Design Review Report – Item 1

government:	City of Stirling	
Item no.:	Item 1 – DA25/1020 – 24 Milldale Way, Mirrabooka – Development Application – Mixed Use – Nine Commercial Tenancies and 16 Multiple Dwellings	
Chairperson:	Munira Mackay	
Panel members:	Tony Blackwell Simon Venturi Peter Damen	Landscape Architecture Architecture Engineering
Local government officers:	Nick Bertone Stefan Tizzone Simone Palmer	Coordinator Planning Senior Planning Officer DRP Support Officer
Observers	Samuel Hay	Undergraduate Planning Officer
Date:	26 February 2026	Time: 2pm
Venue:	City of Stirling – Challenger Room

Design quality evaluation Item 1 – DA25/1020 – 24 Milldale Way, Mirrabooka – Development Application – Mixed Use – Nine Commercial Tenancies and 16 Multiple Dwellings DRP Meeting – Thursday 26 February 2026		
	S	<i>Design Principle satisfied</i>
	P	<i>Design Principle pending further attention</i>
	N	<i>Design Principle not satisfied</i>
Important Note -The Panel noted inconsistencies in the building and landscape drawing set with several plans not correlating, also the inclusion of information irrelevant to the application. The Applicant should review and rectify these discrepancies to

LANDSCAPING PLAN

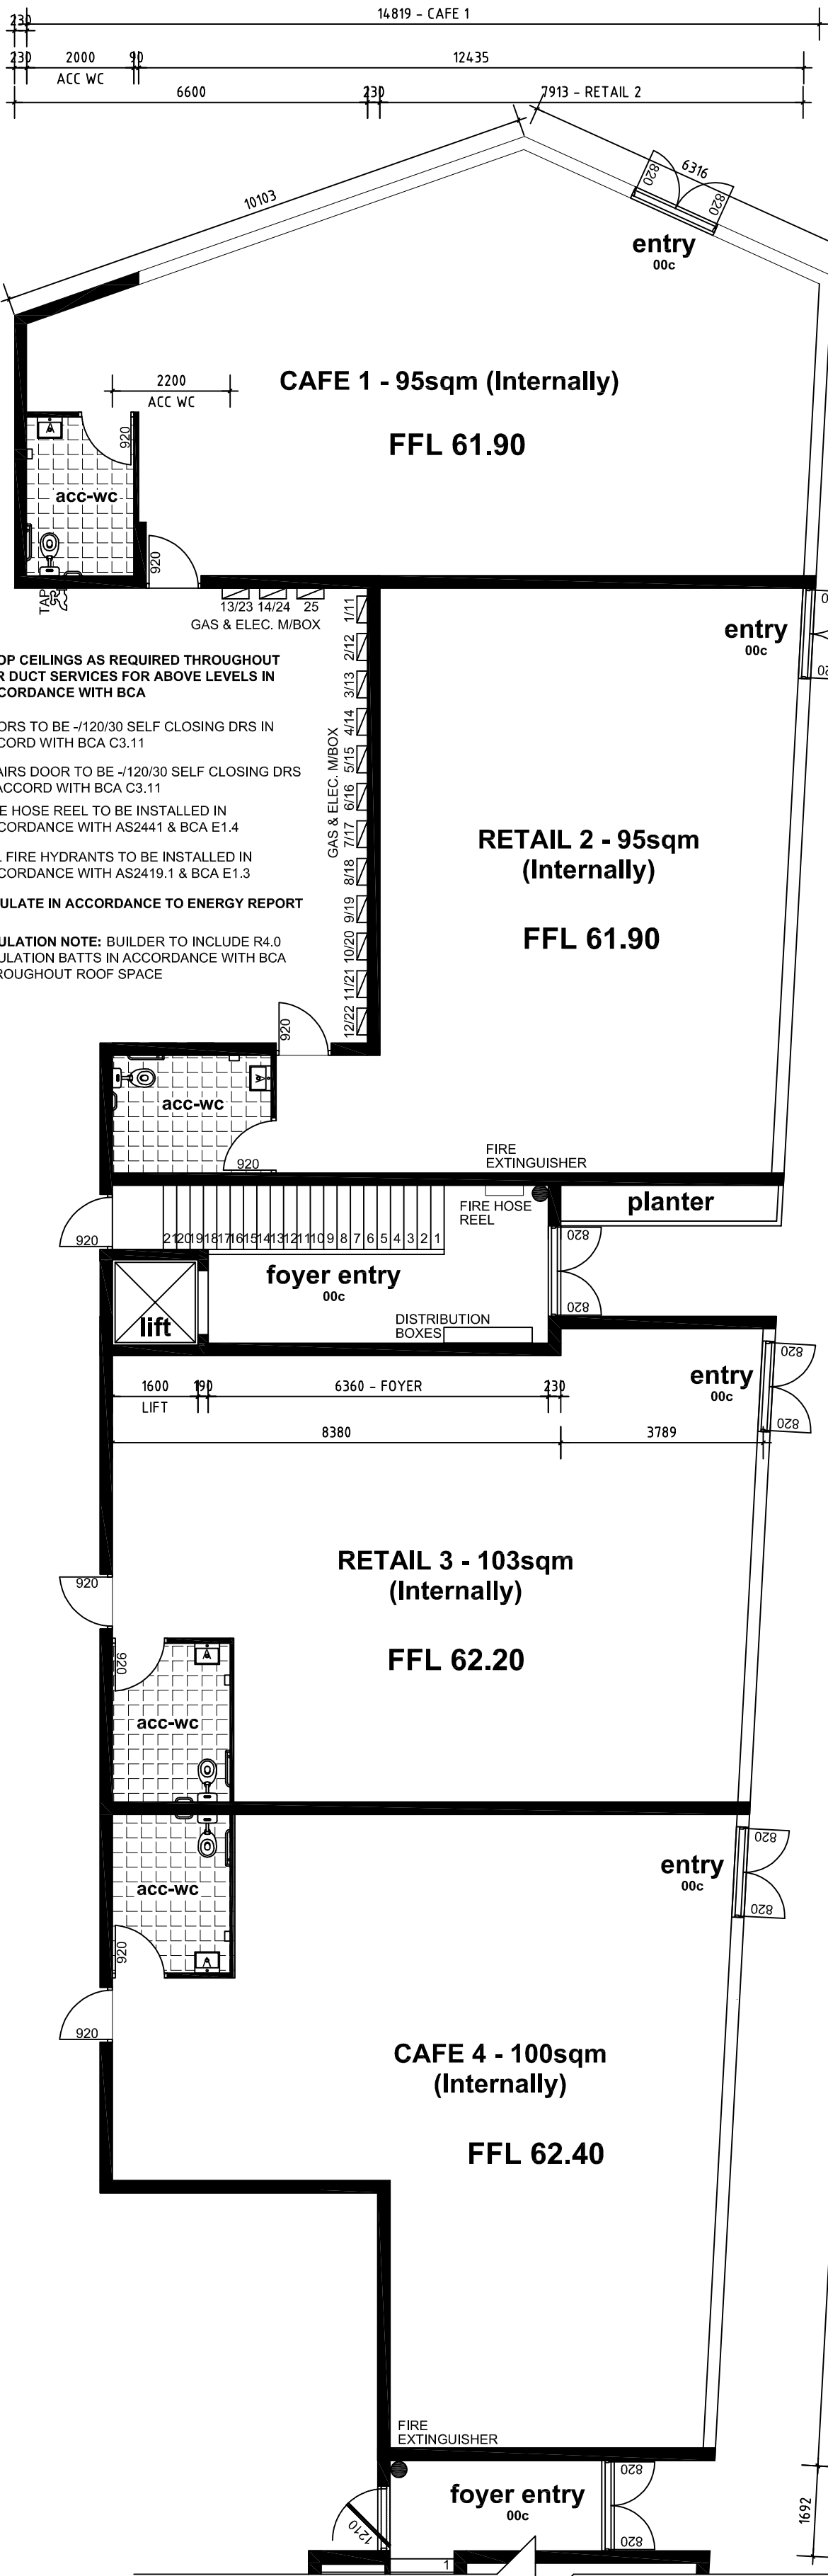
Principle 2 Landscape quality		<i>Good design recognises that together landscape and buildings operate as an integrated and sustainable system, within a broader ecological context.</i>
	N	2a. The current landscape design is low quality, inadequate and poorly located. Provide at least the minimum 10% deep soil area required for appropriately sized trees in meaningful locations on the site. 2b. The current tree wells are deeply recessed and wouldn't support strong growth. Provide locations for trees and other soft landscape, that currently sit on the edge the site or are in the undercover area where there's limited growth potential. 2c. Review and refine the proposed list of plant species to ensure the proposal contributes to local biodiversity. 2d. As per the planning framework, provide well designed, appropriately sized and located communal open space where the development's residents may meet

and socialise. This space should include soft landscaping. 2e. As shown on the elevations, the Panel supports the inclusion of awnings over the public footpath for the climate protection of pedestrians, however these awnings should be shown on the plan. 2f. Clarify and co-ordinate the location of on-structure planting and note the importance of safe access for maintenance. Also note that planting on an awning, as appears on the elevations, is not permitted. 2g. Provide more comprehensive information on the southern boundary fencing. 2h. The Panel strongly advises engaging a Landscape Architect to prepare a high quality and detailed Landscape Plan with all relevant supporting information. The Landscape Plan should include all landscape proposed at the ground level in open spaces and on-structure.
Principle 3 Built form and scale		<i>Good design ensures that the massing and height of development is appropriate to its setting and successfully negotiates between existing built form and the intended future character of the local area.</i>

2a. The current landscape design is low quality, inadequate and poorly

located. Provide at least the minimum 10% deep soil area required for appropriately sized trees in meaningful locations on the site. 2b. The current tree wells are deeply recessed and wouldn't support strong growth. Provide locations for trees and other soft landscape, that currently sit on the edge the site or are in the undercover area where there's limited growth potential. 2c. Review and refine the proposed list of plant species to ensure the proposal contributes to local biodiversity. 2d. As per the planning framework, provide well designed, appropriately sized and located communal open space where the development's residents may meet and socialise. This space should include soft landscaping. 2e. As shown on the elevations, the Panel supports the inclusion of awnings over the public footpath for the climate protection of pedestrians, however these awnings should be shown on the plan. 2f. Clarify and co-ordinate the location of on-structure planting and note the importance of safe access for maintenance. Also note that planting on an awning, as appears on the elevations, is not permitted. 2g. Provide more comprehensive information on the southern boundary fencing.

2h. The Panel strongly advises engaging a Landscape Architect to prepare a high quality and detailed Landscape Plan with all relevant supporting information. The Landscape Plan should include all landscape proposed at the ground level in open spaces and on-structure.			
3a. The proposed development on the site is overly intensive with excessive ground level commercial space and 16 residential units ‘squeezed’ on to the upper level; this approach has led to overdevelopment and a subsequent significant loss of: - landscape quantity and design quality - functionality of the development, particularly in the carpark and servicing of the commercial - natural amenity for the residents’ communal areas and apartments. 3b. In view of the above comment, the Panel strongly advises decreasing the commercial floor area and, if maintaining or increasing the yield, considering additional storey height (the City’s planning framework permits 2-storey minimum height and 5-storey maximum on the site) to release ground level space for landscape and improved functionality of the rear carpark/yard. The apartment plans should be revised to achieve high quality amenity for the residents. Refer to further

UNITS 1-6 & 16 FIRST FLOOR PLAN

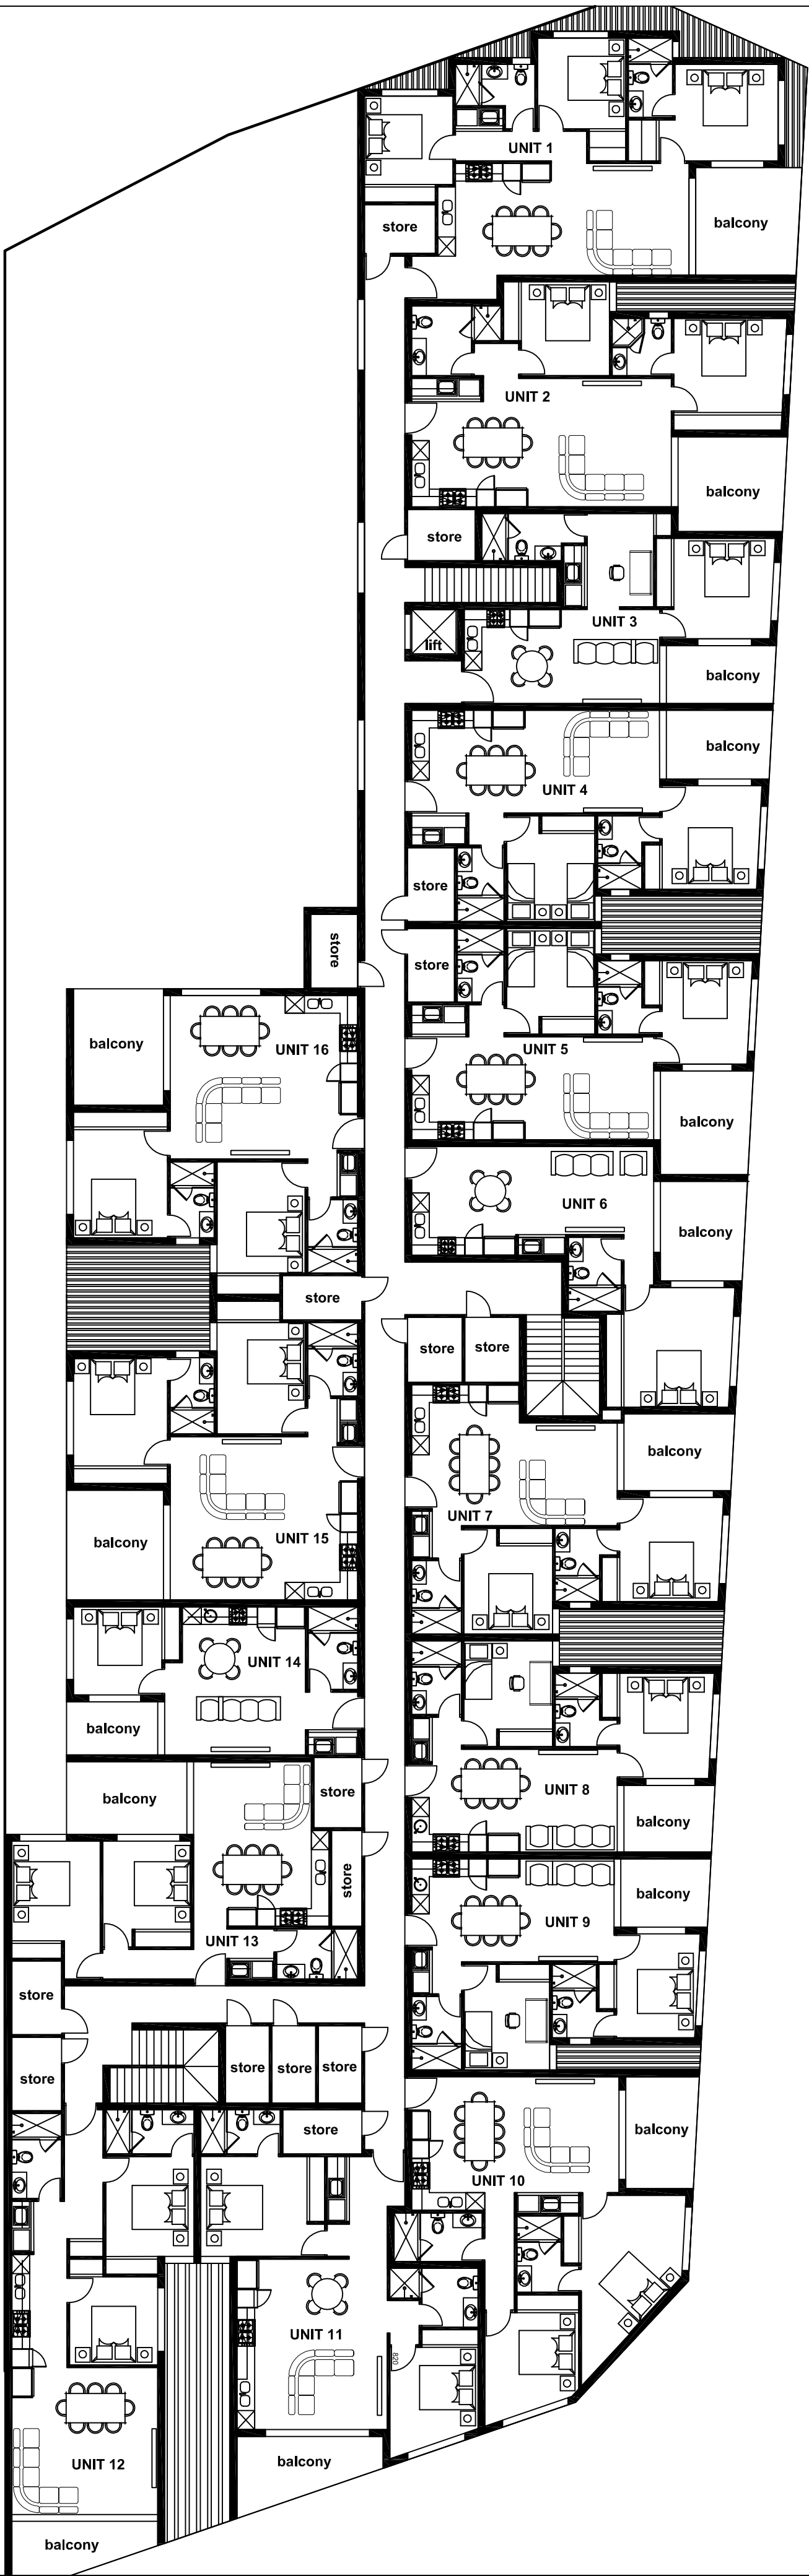
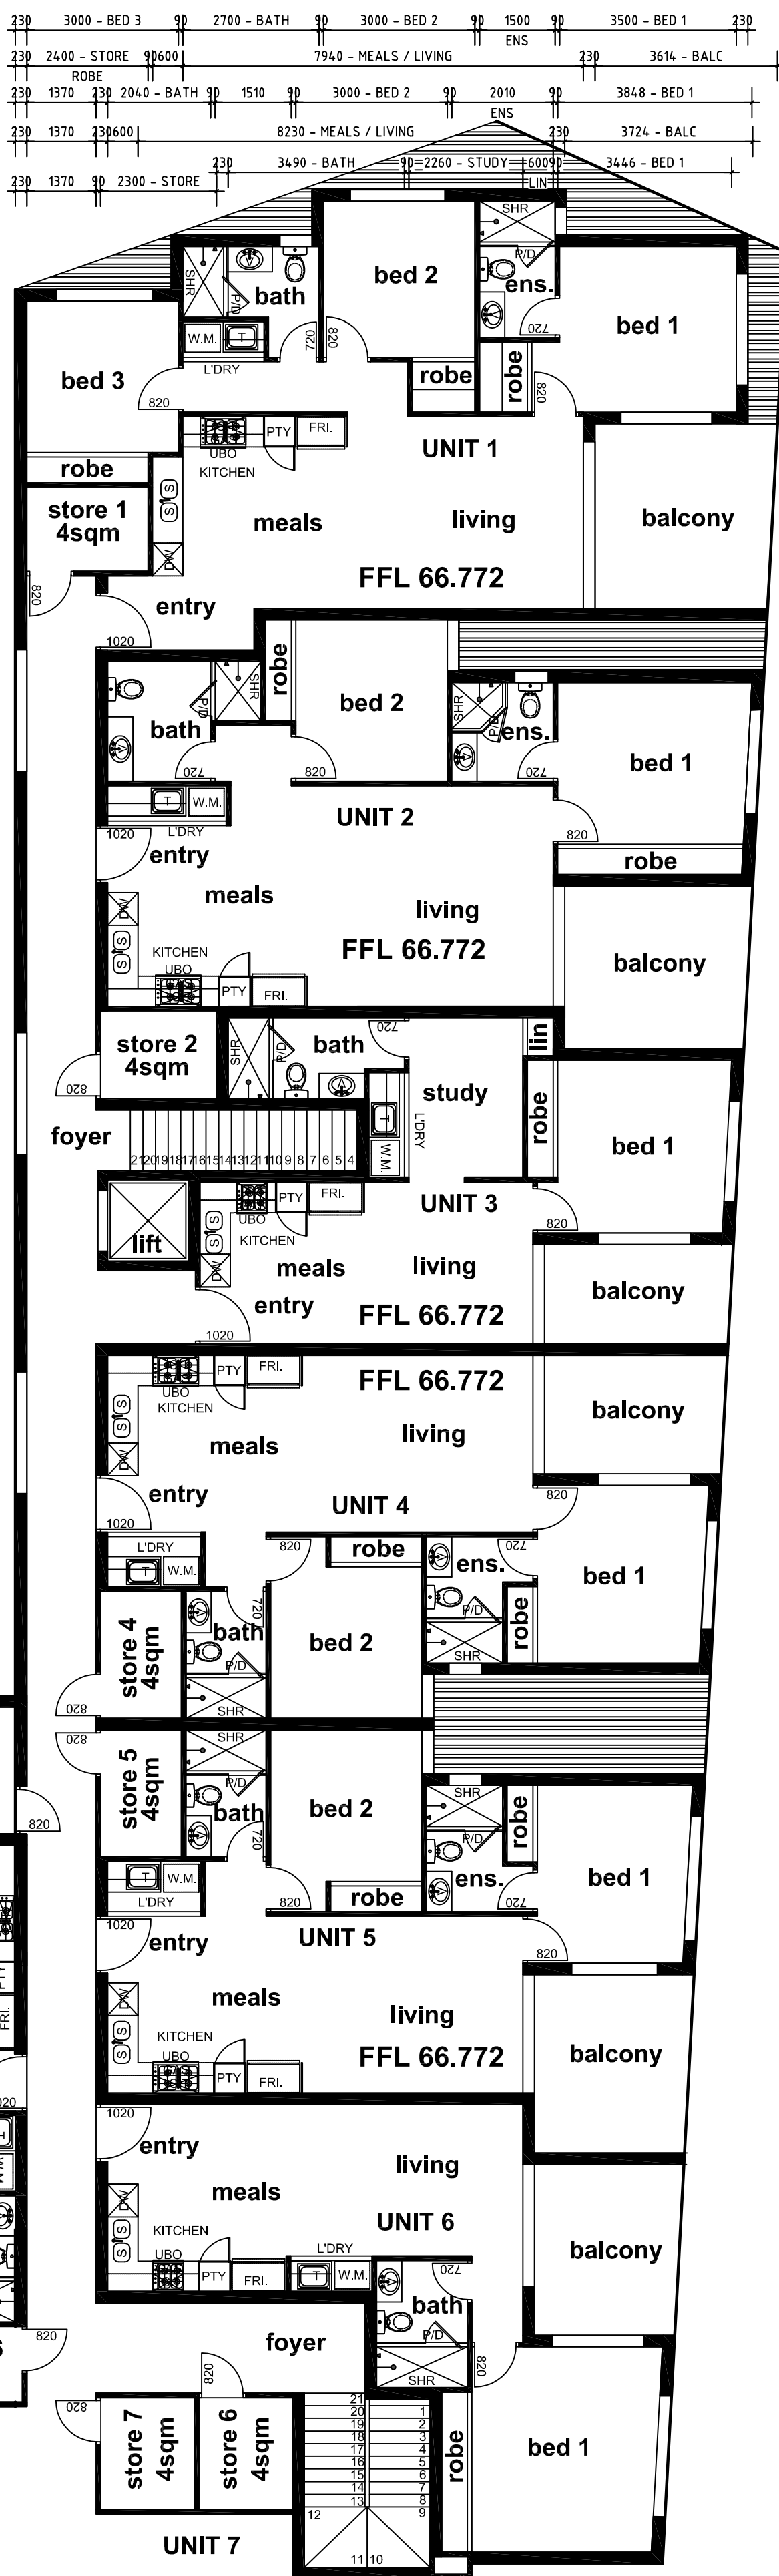
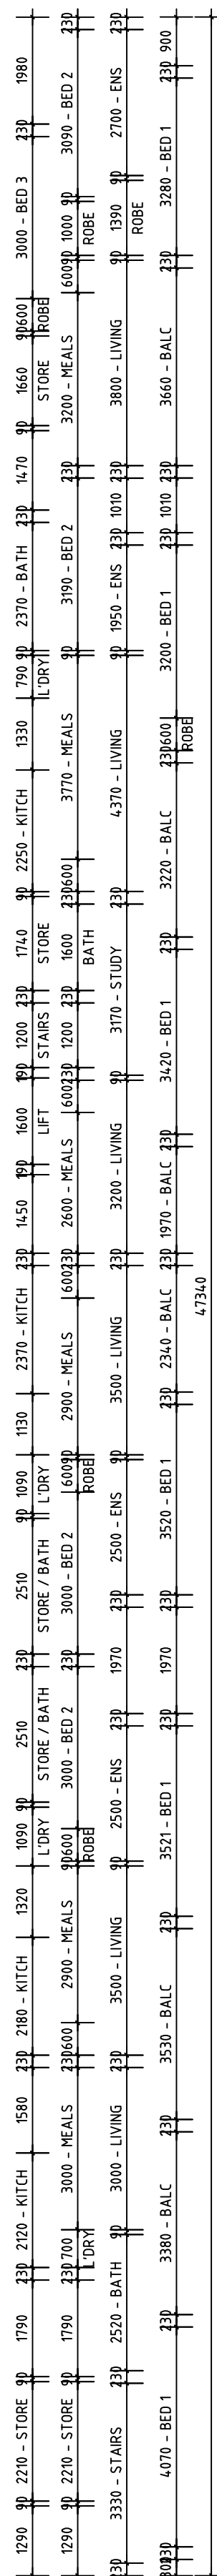
N	6a. The “snorkel” windows with long, narrow recesses severely limit outlook, natural light access and cross ventilation into the habitable rooms located deep within the apartment plan and, furthermore, the glazing and recesses would be difficult to maintain. The Panel does not support the use of “snorkel” windows. - From a broader perspective and as per the comments in <i>Principle 3 - Built Form and Scale</i> and in this <i>Principle 6 - Amenity</i>, the Panel strongly recommends revision of the entire layout and better meeting the requirements of the <i>Residential Design Codes Volume 2 – Apartments</i>. 6b. The current solar access diagrams are confusing as the colour coding key varies between units and is applied inconsistently. Further to the Panel’s recommendation to revise the residential planning, provide supporting and accurate diagrams on the access of natural amenity (breeze flow, daylight and mid-winter solar access) into the habitable rooms of each apartment The Panel’s comments below highlight issues that should be addressed or not repeated in any revision of the apartment planning. 6c. Refer Unit 12 - a circulation hall should not be in a galley kitchen. 6d. For all kitchens - layouts should include work top space for food preparation. 6e. Refer Unit 9 - living area is too small and should be enlarged. 6f. Refer Unit 14 – balcony width is only 1.8m and limited in area. This should be enlarged to a 2m minimum dimension and increased in size. Many balconies are very small and, in addition to this, no communal space is provided in the development. 6g. Apartment stores are randomly located within the communal corridor impacting on apartment layouts. Consider a clear strategy for legible locations and accessibility of these stores by residents and to improve the overall residential floor plan. 6h. The communal corridor is too narrow for two people to pass, let alone move bulky furniture. Consider 1.5m minimum for the communal corridor. 6i. For all apartments and the communal corridors – consider operable windows for natural ventilation.

6a. The “snorkel” windows with long, narrow recesses severely limit outlook, natural light access and

cross ventilation into the habitable rooms located deep within the apartment plan and, furthermore, the glazing and recesses would be difficult to maintain. The Panel does not support the use of “snorkel” windows. - From a broader perspective and as per the comments in Principle 3 - Built Form and Scale and in this Principle 6 - Amenity, the Panel strongly recommends revision of the entire layout and better meeting the requirements of the Residential Design Codes Volume 2 – Apartments. 6b. The current solar access diagrams are confusing as the colour coding key varies between units and is applied inconsistently. Further to the Panel’s recommendation to revise the residential planning, provide supporting and accurate diagrams on the access of natural amenity (breeze flow, daylight and mid-winter solar access) into the habitable rooms of each apartment The Panel’s comments below highlight issues that should be addressed or not repeated in any revision of the apartment planning. 6c. Refer Unit 12 - a circulation hall should not be in a galley kitchen. 6d. For all kitchens - layouts should include work top space for food preparation. 6e. Refer Unit 9 - living area is too small and should be enlarged. 6f. Refer Unit 14 – balcony width is only 1.8m and limited in area. This

should be enlarged to a 2m minimum dimension and increased in size. Many balconies are very small and, in addition to this, no communal space is provided in the development. 6g. Apartment stores are randomly located within the communal corridor impacting on apartment layouts. Consider a clear strategy for legible locations and accessibility of these stores by residents and to improve the overall residential floor plan. 6h. The communal corridor is too narrow for two people to pass, let alone move bulky furniture. Consider 1.5m minimum for the communal corridor. 6i. For all apartments and the communal corridors – consider operable windows for natural ventilation.			
7a. The development includes three separate and recessed residential entrances, including one entry in the building's southernmost rear corner that is illegible for visitors. To improve legibility and safety for residents and visitors alike, provide one main residential entry from Milldale Way.

MILLDALE WAY VIEW

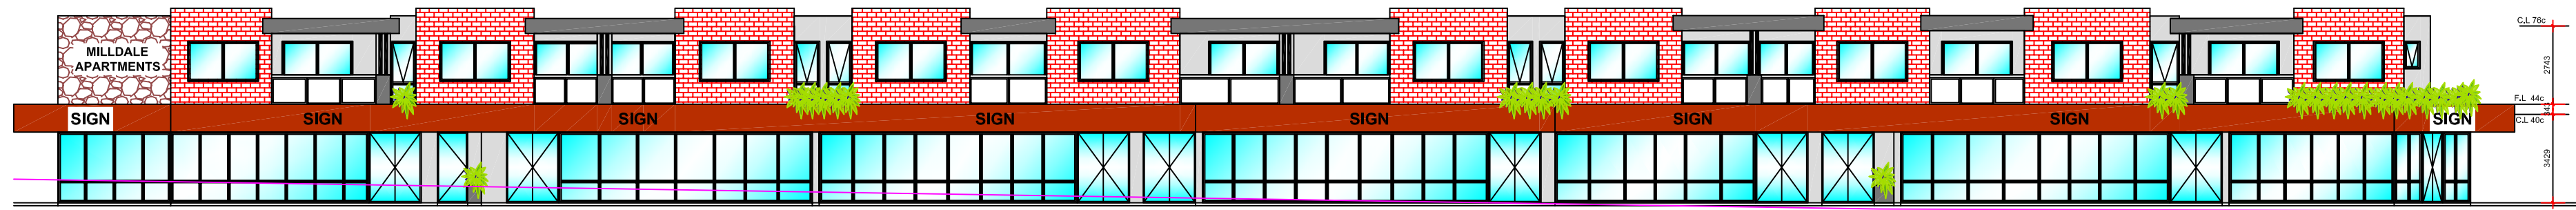
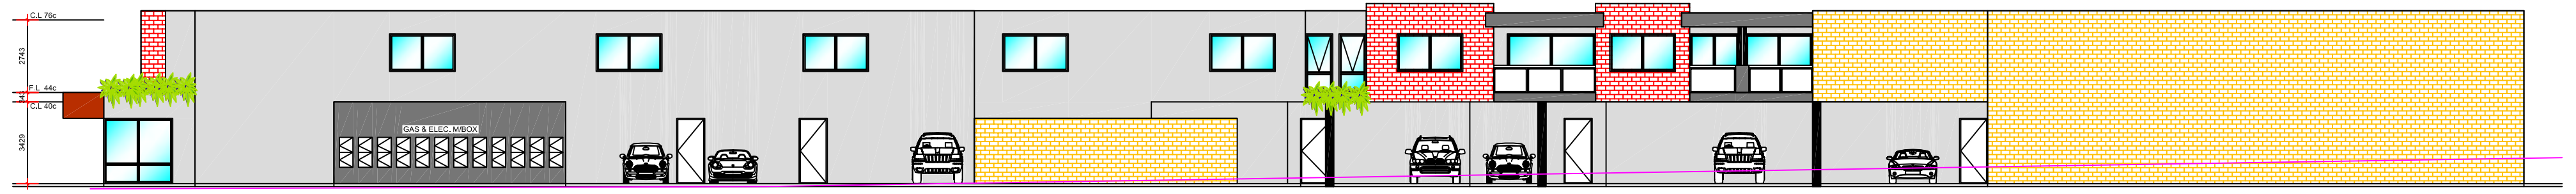
8a. Refer to the comments above in Principle 7 – Legibility, given legibility and safety are connected and Principle 4 – Functionality and Build Quality.			
10a. The rear south-western elevation appears flat and unfinished with little visual interest (the rear is visible from the adjacent Bus

station). Consider greater articulation of the elevation through finer-grain detailing and greater diversity of materiality. 10b. The street front elevations include an overly complex materials and colours palette. Consider simplification and a clear rationale for the palette (note: brick and stone are load bearing materials that shouldn't be applied randomly, as in this case at the upper level). 10c. The shopfronts read as very commercial facades. Consider introducing finer grain materials, breaking up the fenestration design and provide opportunities for each business to personalize their facade. 10d. As public art is a mandatory component of the development, consider artwork at an early stage that is appropriately located and will contribute meaningfully to the development as well as the surrounding context within the Mirrabooka Town Centre.			
--	--	--	--
